Request for Additional Information No. 30, Revision 0

U. S. EPR Standard Design Certification

AREVA NP Inc.

**SRP Section: 15.06.05 – Loss of Coolant Accidents Resulting From Spectrum of
Postulated Piping Breaks Within the Reactor Coolant Pressure Boundary**

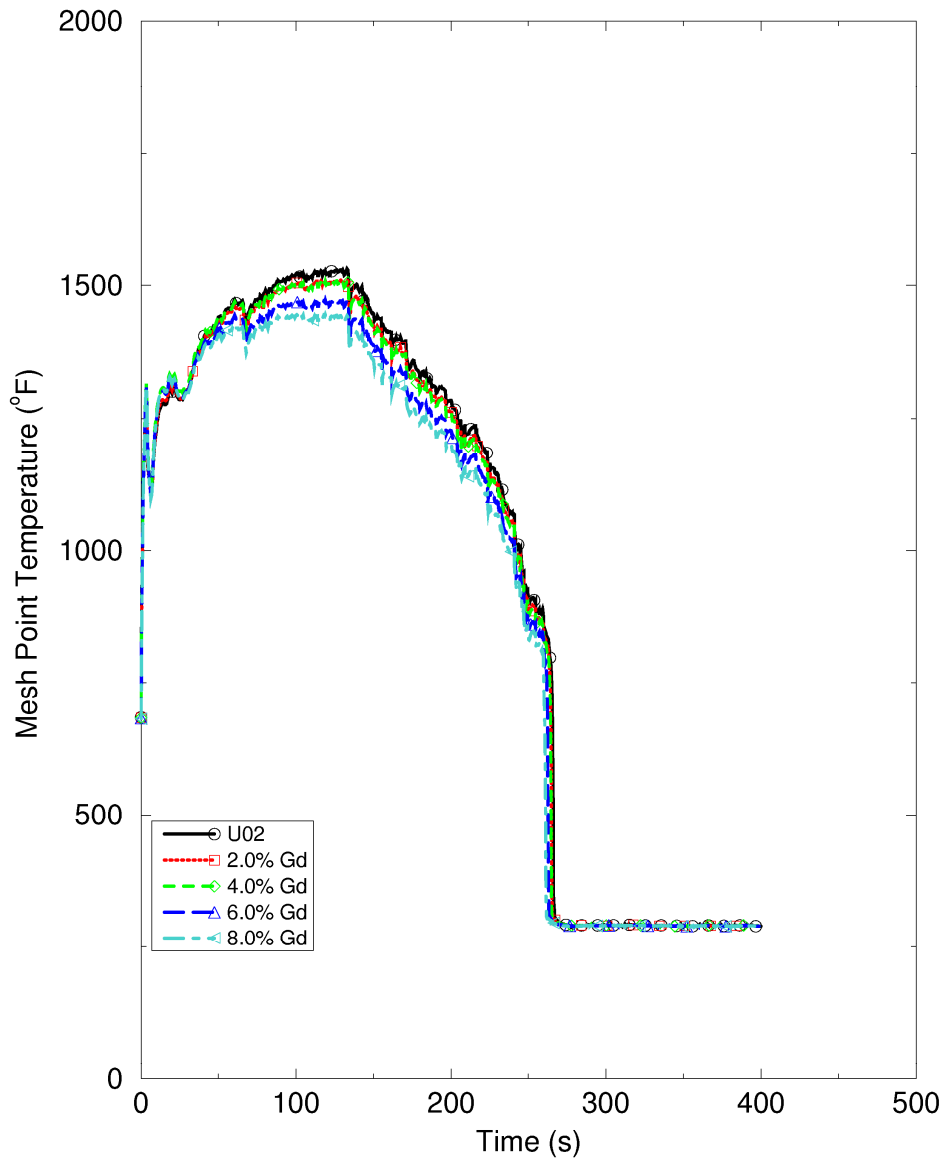
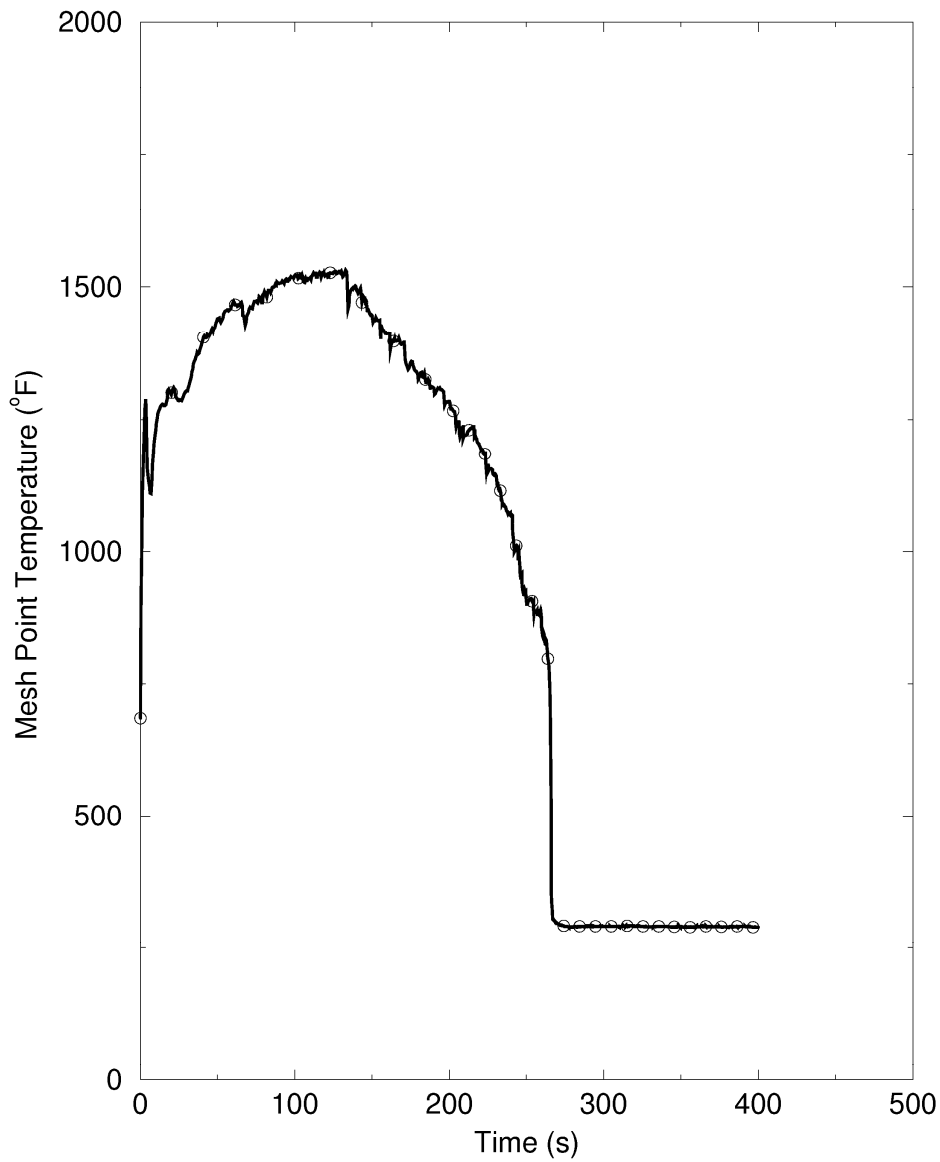
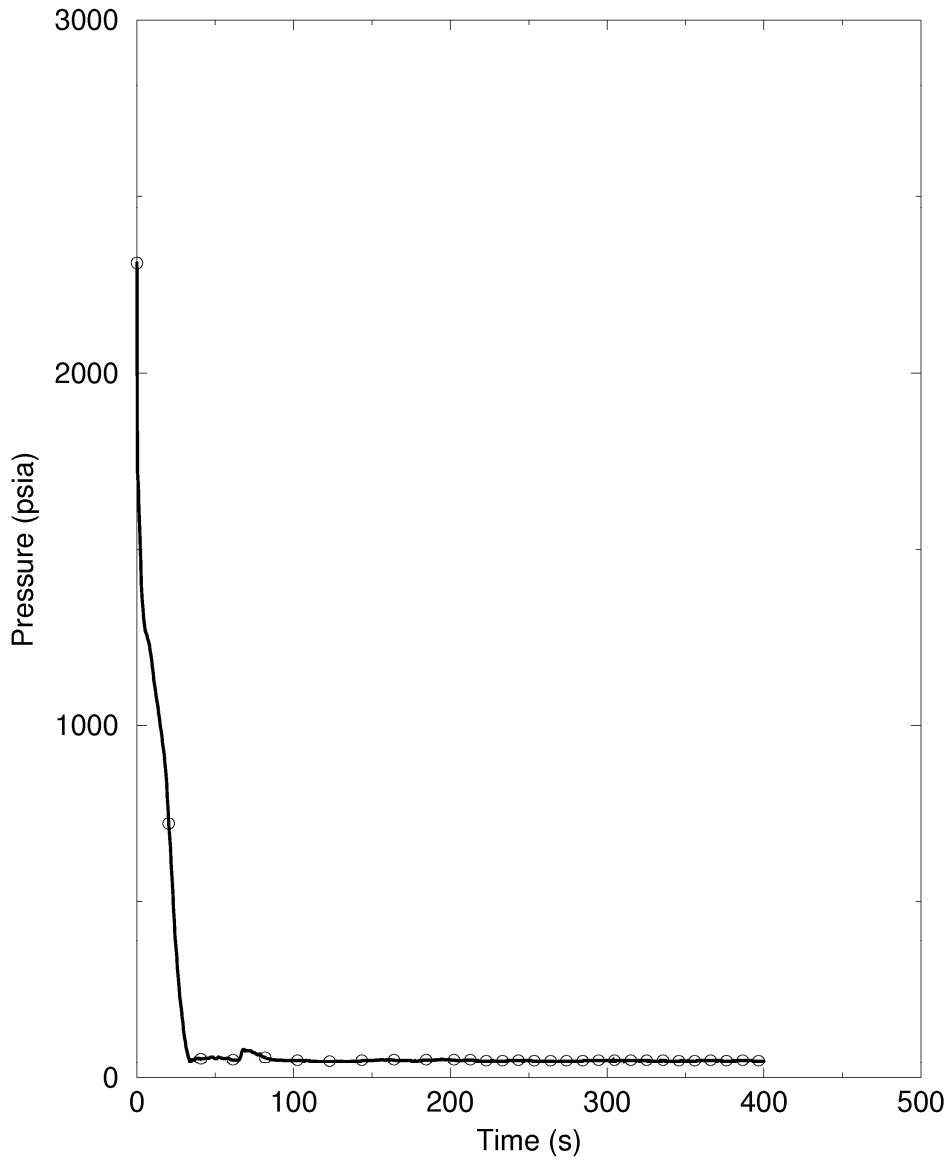
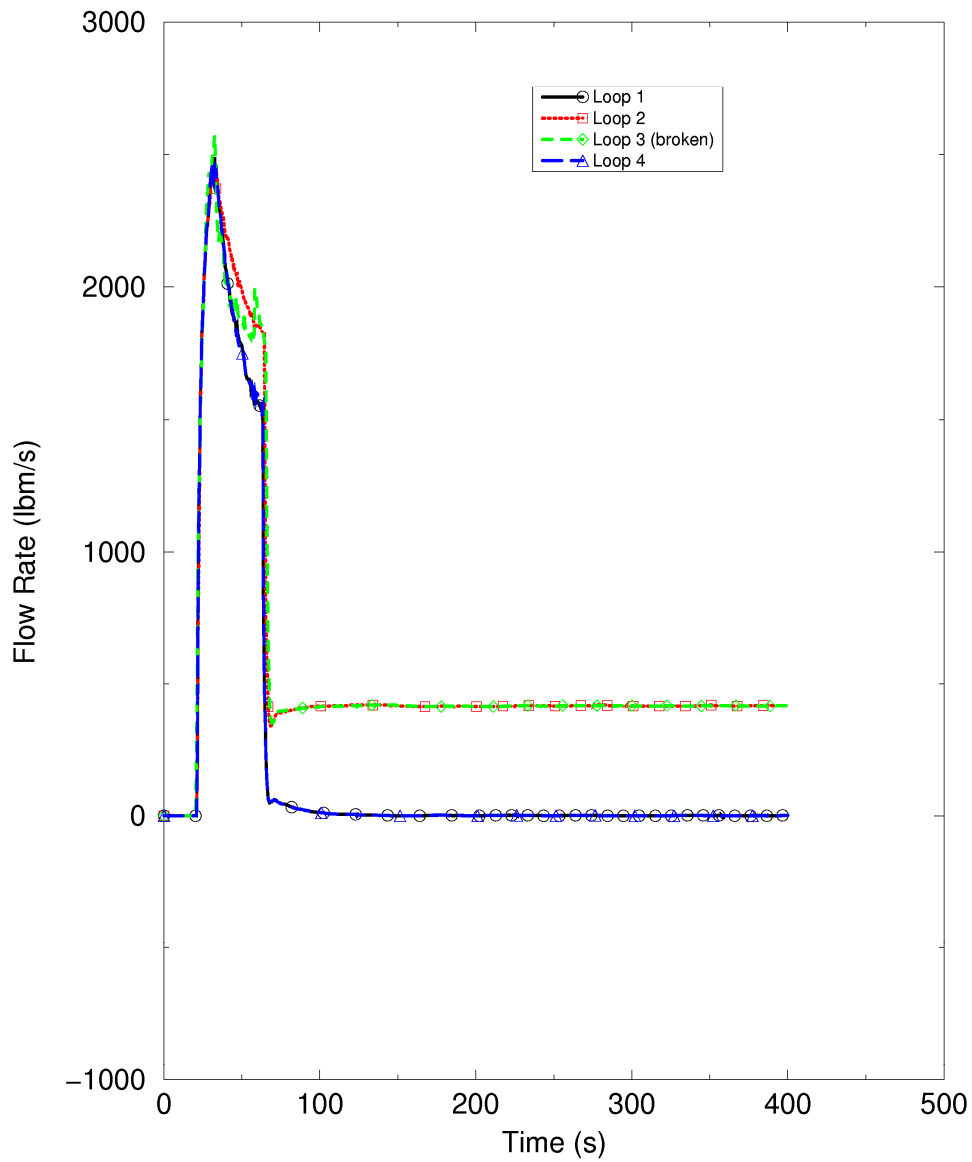
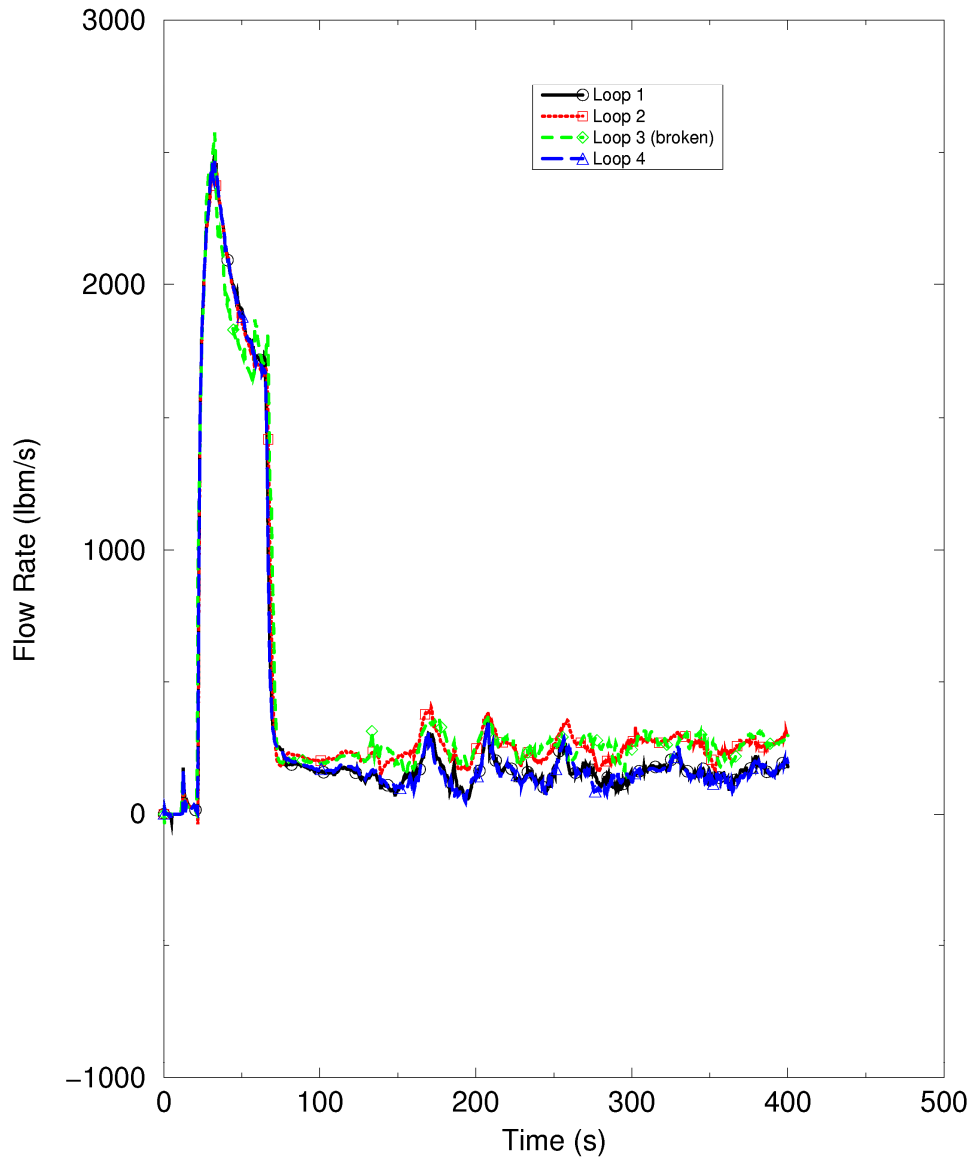
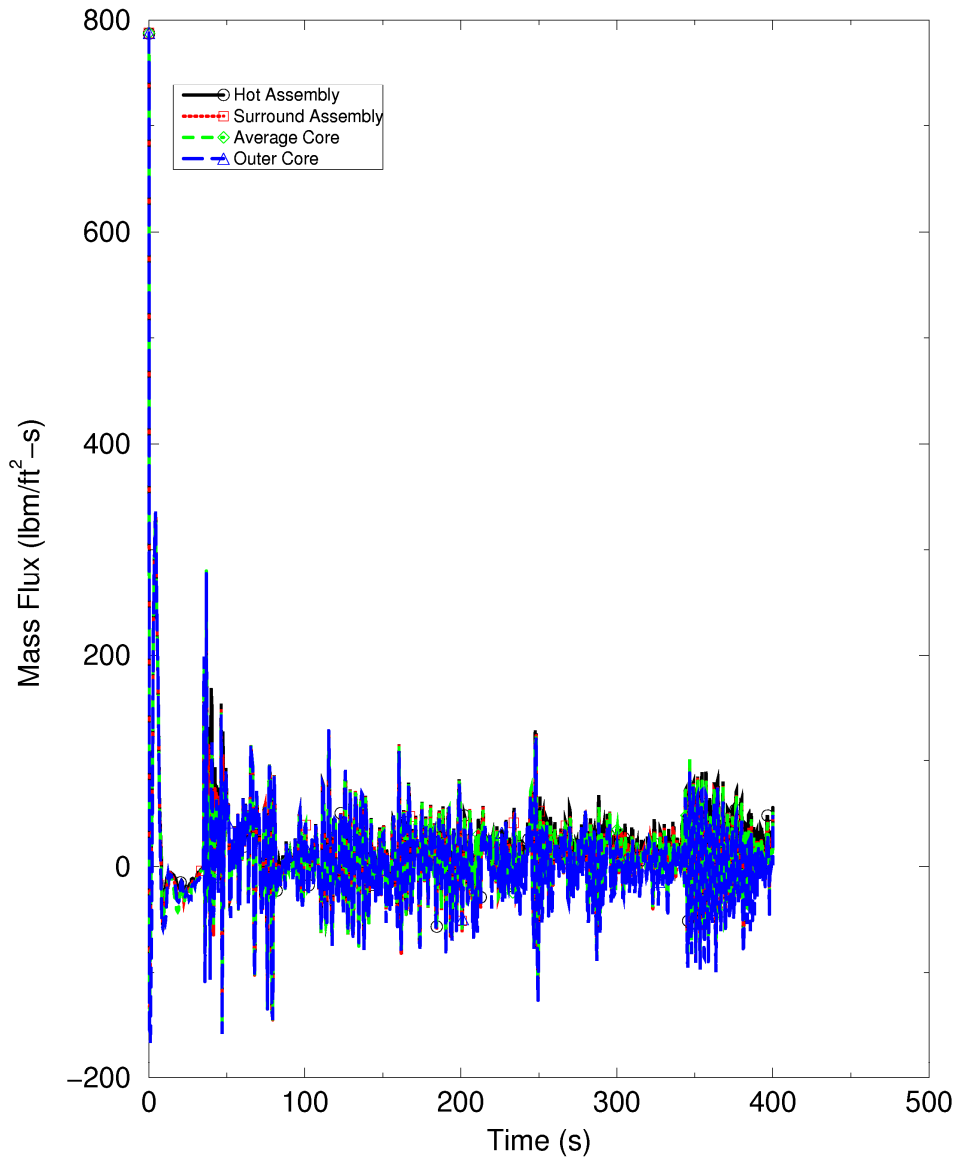
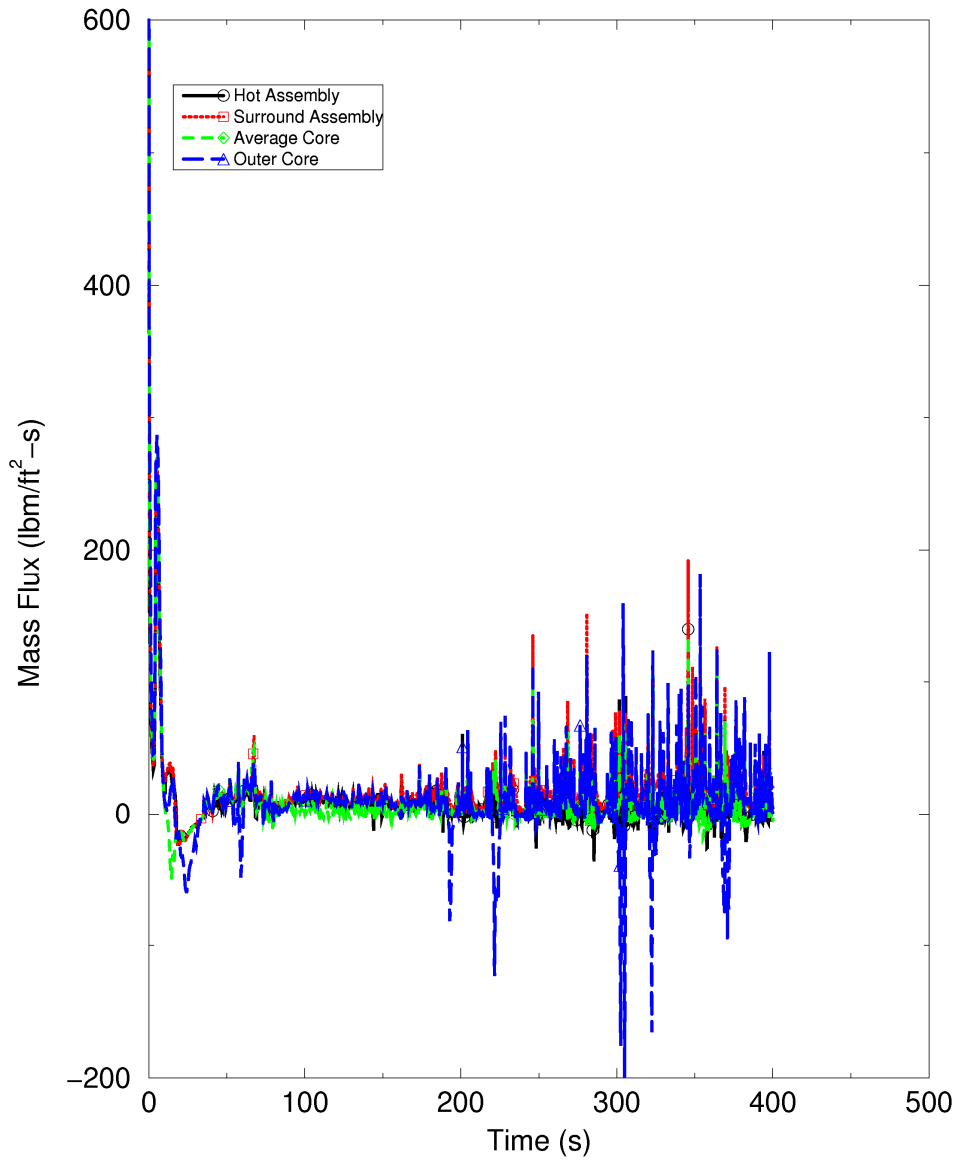
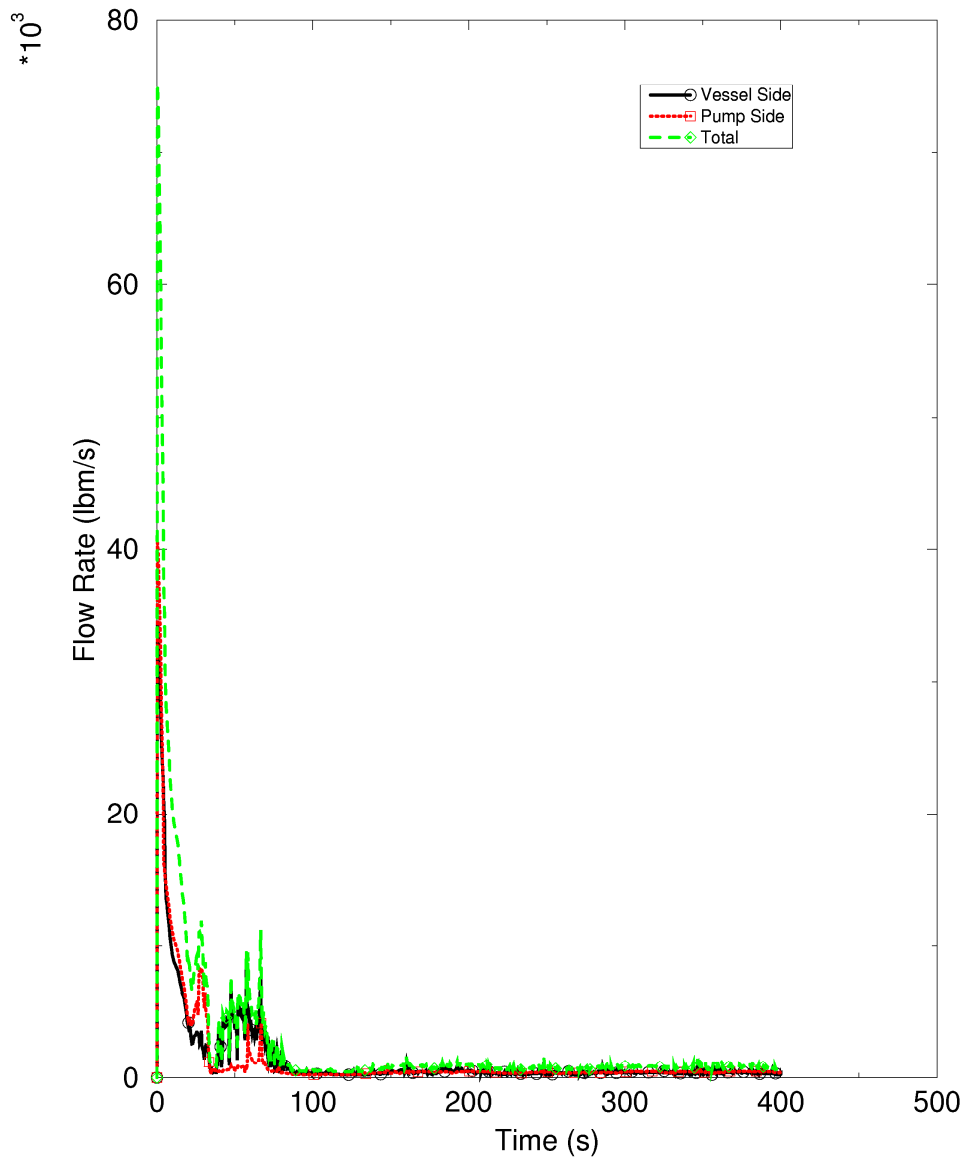
Plotted information has only been provided for the equilibrium cycle case. Please provide a set of plots similar to FSAR Figures 15.6-27 through 15.6-50 for the limiting PCT initial cycle case.

The requested figures are provided.
